ADDENDUM NUMBER 5

- 1.01 DATE: MARCH 26, 2021**
- 1.02 PROJECT: BUS STORAGE FACILITY**
- 1.03 PROJECT NUMBER: DCM NO. 2020191**
- 1.04 OWNER: ALABAMA A&M UNIVERSITY**
- 1.05 ARCHITECT: NOLA | VAN PEURSEM ARCHITECTS, PC**

BUS STORAGE FACILITY
ALABAMA A&M UNIVERSITY
NORMAL, ALABAMA

SHEET NUMBER
C5.0

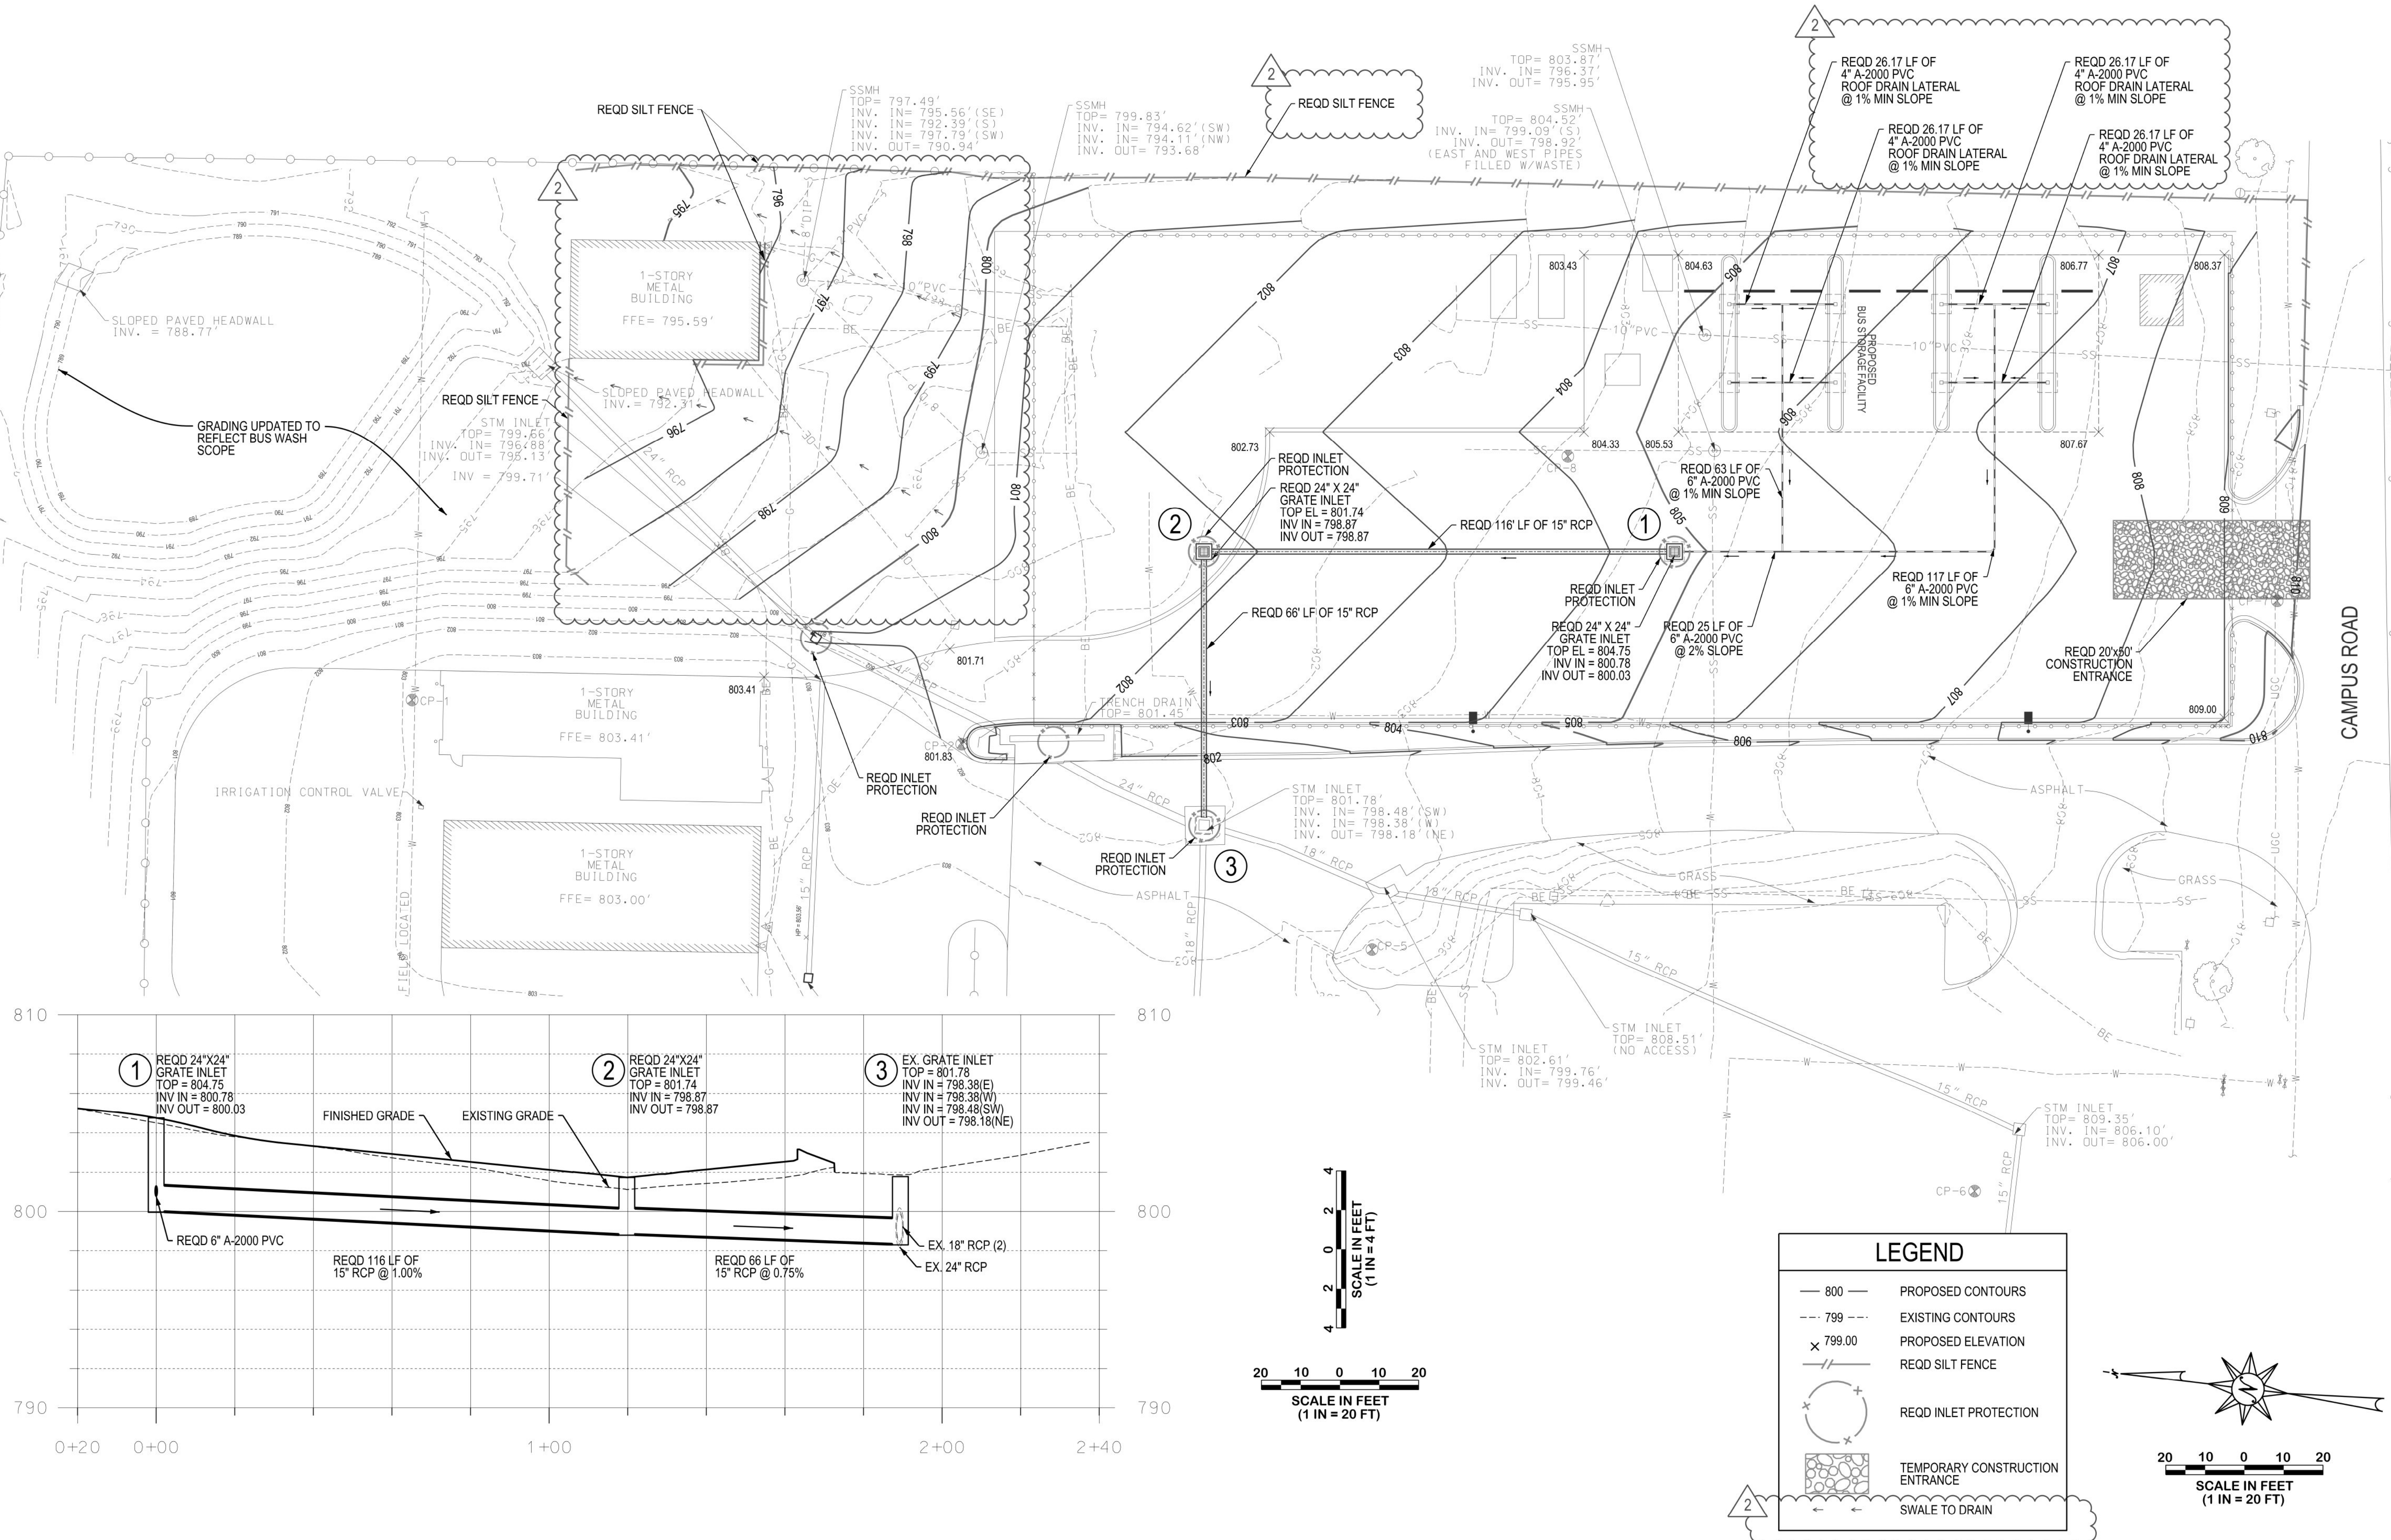
- 4.01 SHEET C-5.0 – CIVIL GRADING, DRAINAGE & EROSION CONTROL PLAN:**
 - A. Replace this sheet in its entirety. Revisions include the following:
 - 1. Updated grading along north end of site.
 - 2. Updated detail notes.
